Service Bulletin

Subject: Rattle or Buzz Noise from Rear of Vehicle and/or Rear Wheel Liner Hanging Down

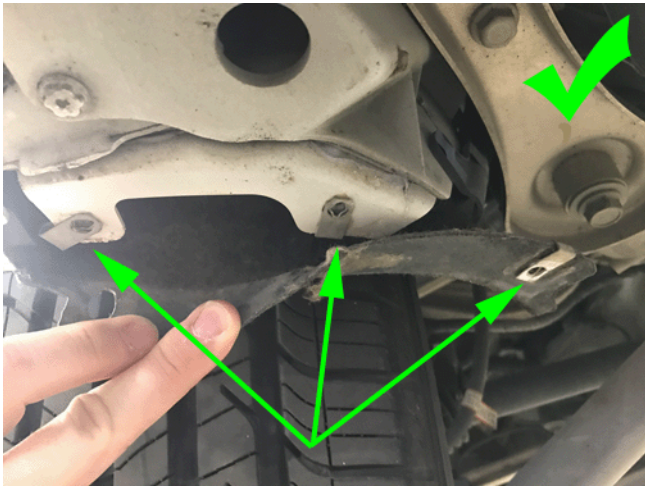
| Condition | Some customers may comment on a rattle or buzz noise from the rear of the vehicle or that the rear wheel liner(s) are hanging down. |
| Cause |  <p>This may be due to incorrect installation of the j-clips installed onto the wheel liner and not onto the sheet metal.</p> |

If you encounter a vehicle with the above concern, install the j-clips onto the sheet metal flange as illustrated above and re-insert the 3 screws.
